SERVICE TIPS

GAME: COLONY 7

81-5

82-13

FIGURE 1.

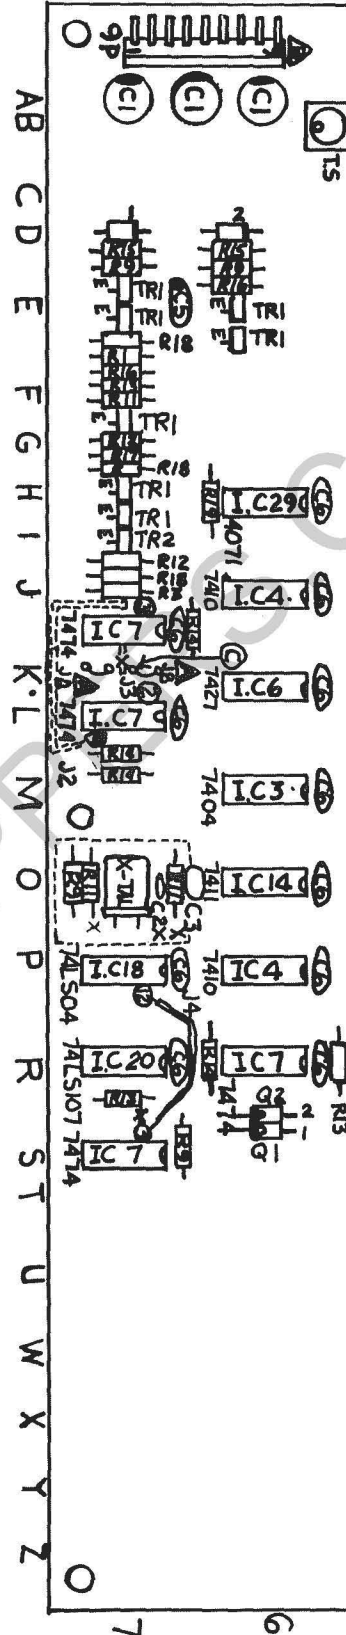
SUBJECT: FRAGMENT OF EXPLOSION STAYS ON THE SCREEN. FALSE END OF GAME.
IF YOUR HAND GETS NEAR THE CRYSTAL THE VIDEO WILL BE DISTORTED.

SOLUTION: STABILIZE TIMING CIRCUIT BY CHANGING VALUES OF FEEDBACK
RESISTOR.

PROCEDURE: REPLACE THE TWO (2) RESISTORS (R11) AT LOCATION O7 ON THE CPU BOARD, REFER TO FIGURE 1. WITH TWO (2) 470 OHM RESISTORS. THEN CHANGE THE 22pf CAPACITOR AT THE SAME LOCATION, WITH A 180pf CAPACITOR.

PARTS NEEDED: TWO (2) 470 OHM RESISTORS
ONE (1) 180pf CAPACITOR

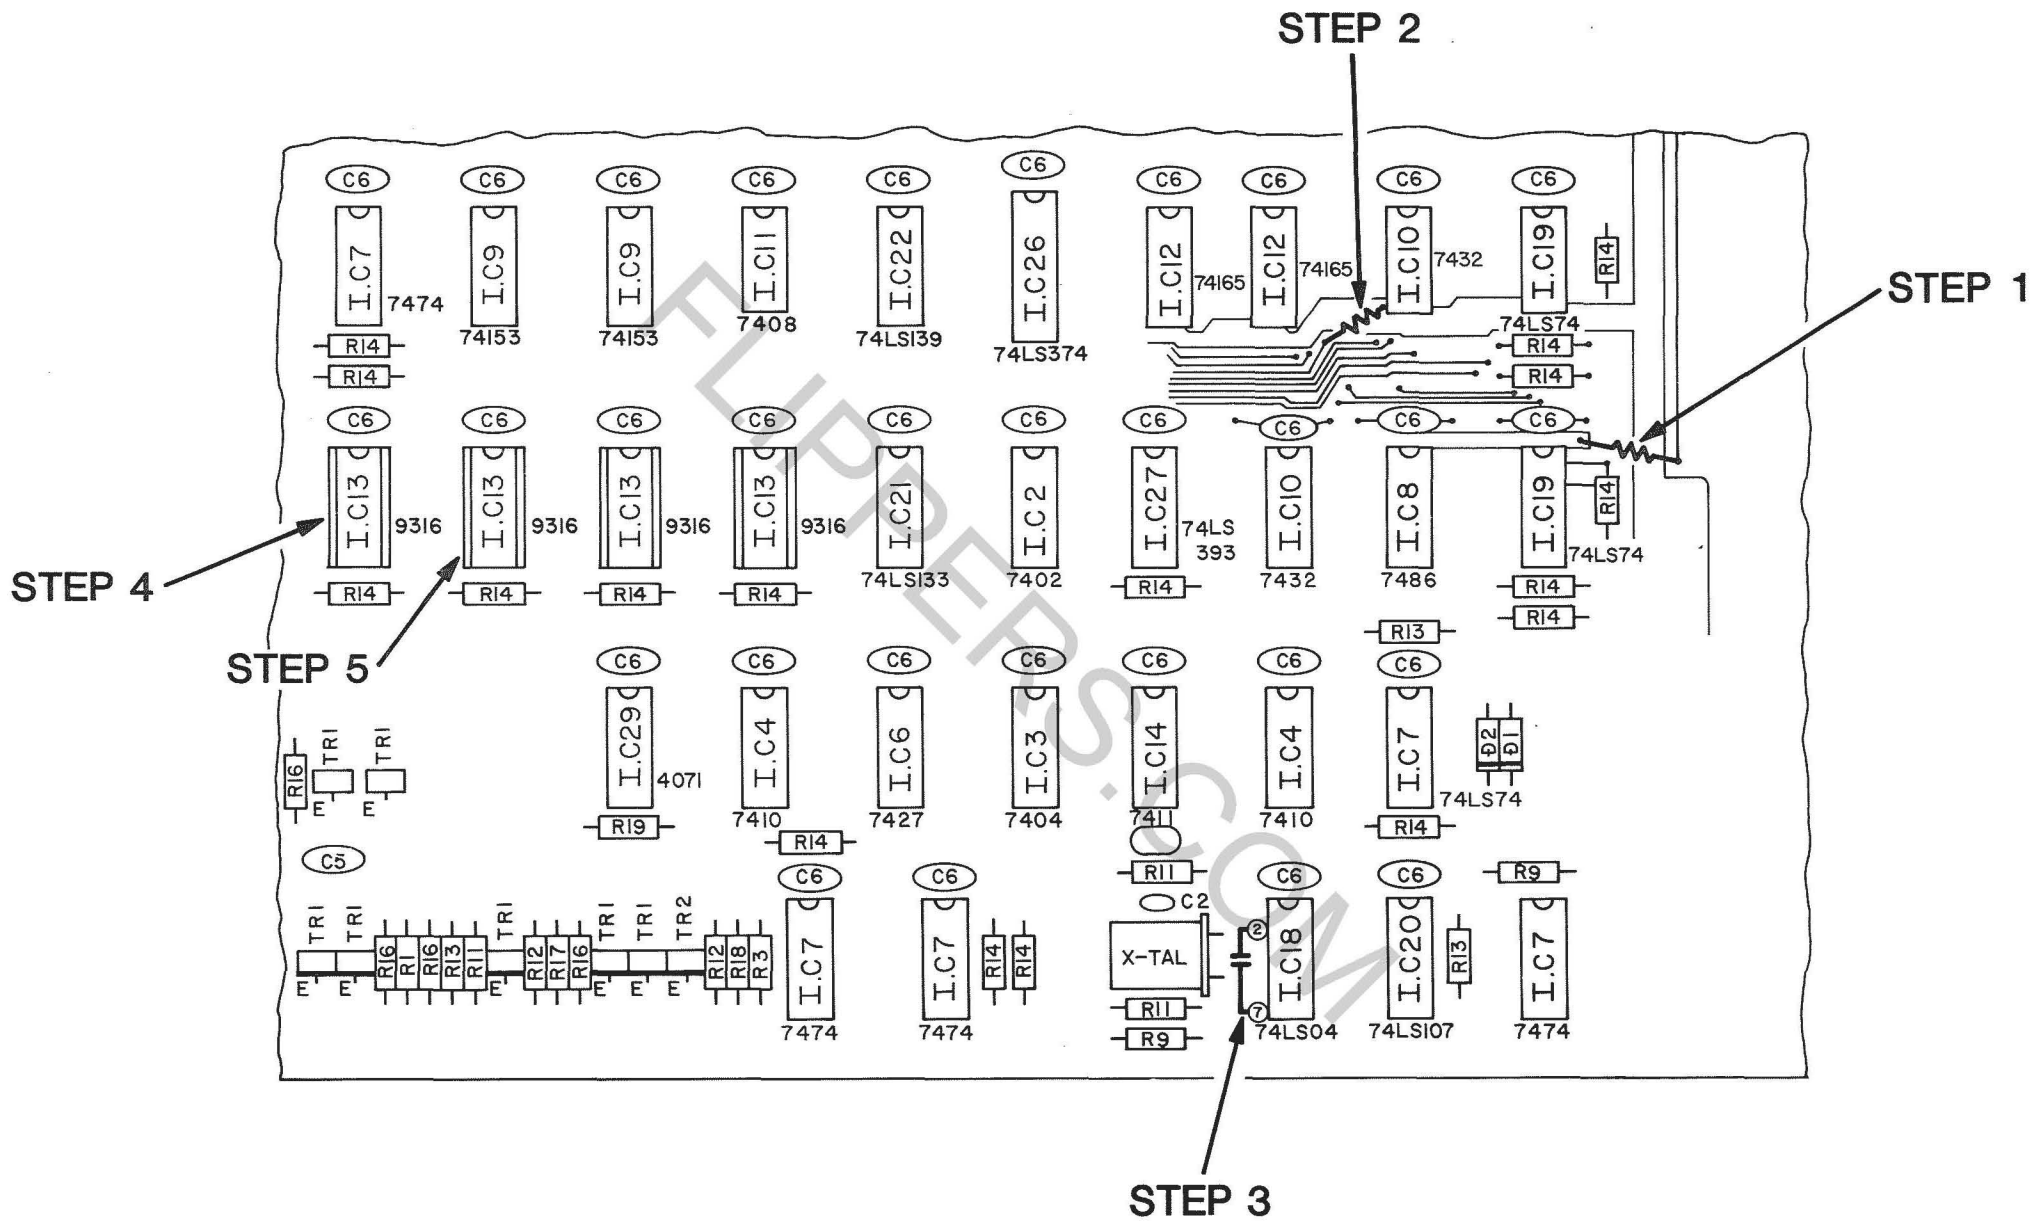
SUBJECT: DOT ON SCREEN OR INTERMITTANT FREEZE-UP

SOLUTION: IMPROVE MULTIPLEXING TIMING CIRCUIT BY ADDING PULL UP
RESISTORS TO CAS AND A PULL DOWN RESISTOR TO RAS.

PROCEDURE: FIRST DO THE MODIFICATION STATED IN SERVICE TIP 81-5.
IN ADDITION TO THAT PROCEDURE ADD A 2.2K OHM RESISTOR TO THE CAS
ETCH AS POINTED OUT IN FIGURE 1 AS STEP 1.

IF PART OF THE LETTERING IS MISSING OR SOME DOTS ARE STILL ON THE
SCREEN ADD THE 2.2K OHM RESISTOR TO THE RAS ETCH AS POINTED OUT IN
FIGURE 1 AS STEP 2.

IN SOME CASES, A 220pf CAPACITOR WILL NEED TO BE ADDED TO THE IC
AT LOCATION 7P BETWEEN PINS 2 AND 7 AS SHOWN IN STEP 3 IN FIGURE
1. THE 74161 AT LOCATION 5E (STEP 4) CAUSES TEARING IN PICTURE,
PICTURE ROLLING, OR IT WILL CAUSE A RESET.

THE 74161 AT LOCATION 5F (STEP 5) CAUSES HORIZONTAL SYNC PROBLEMS.

WHEN THESE 74161 CHIPS NEED TO BE REPLACED, PLEASE USE 74161 BY
SIGNETICS.

PARTS NEEDED: TWO 2.2K OHM RESISTORS
ONE 220pf CAPACITOR

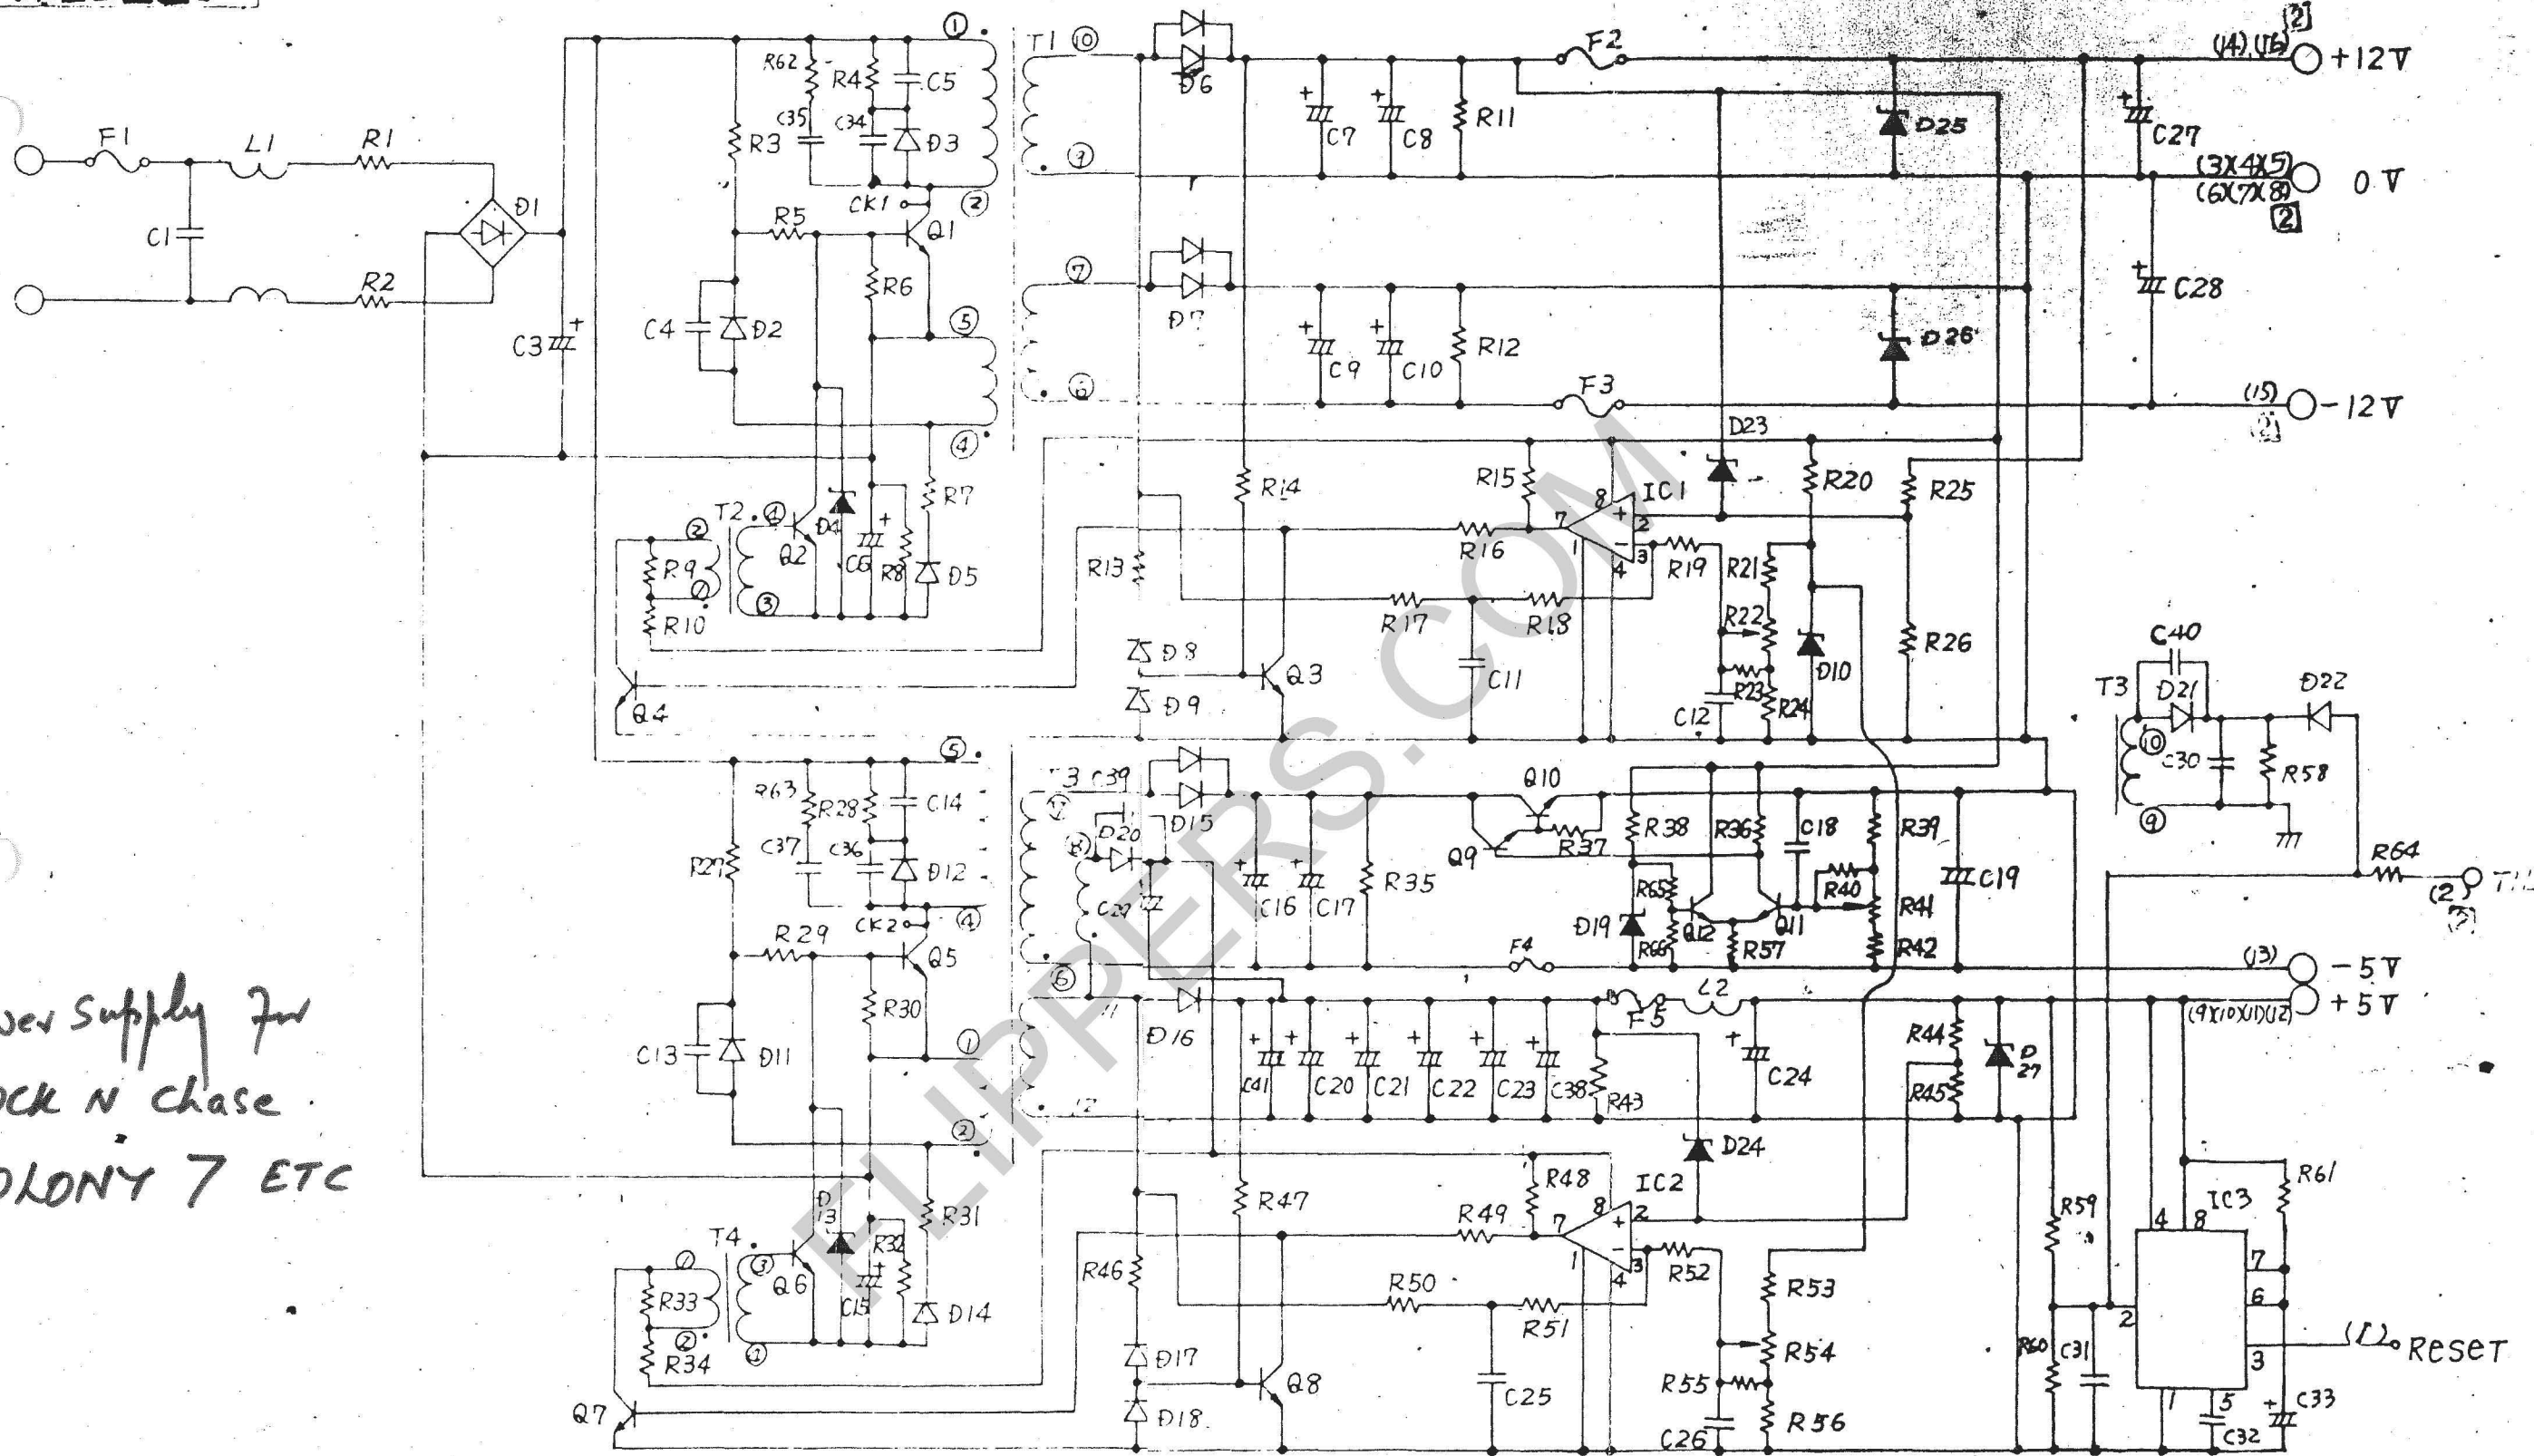
PROBLEM: PUTTING COIN IN DURING ATTRACT MODE DOES NOT ALWAYS PRODUCE CREDIT

SOLUTION: CHANGE ROM'S CS01, CS02, CS03 PER ILLUSTRATIONS

REPLACE CS01 WITH 16-00003-011, CS02 WITH 16-00003-012, AND CS03 WITH 16-00003-013
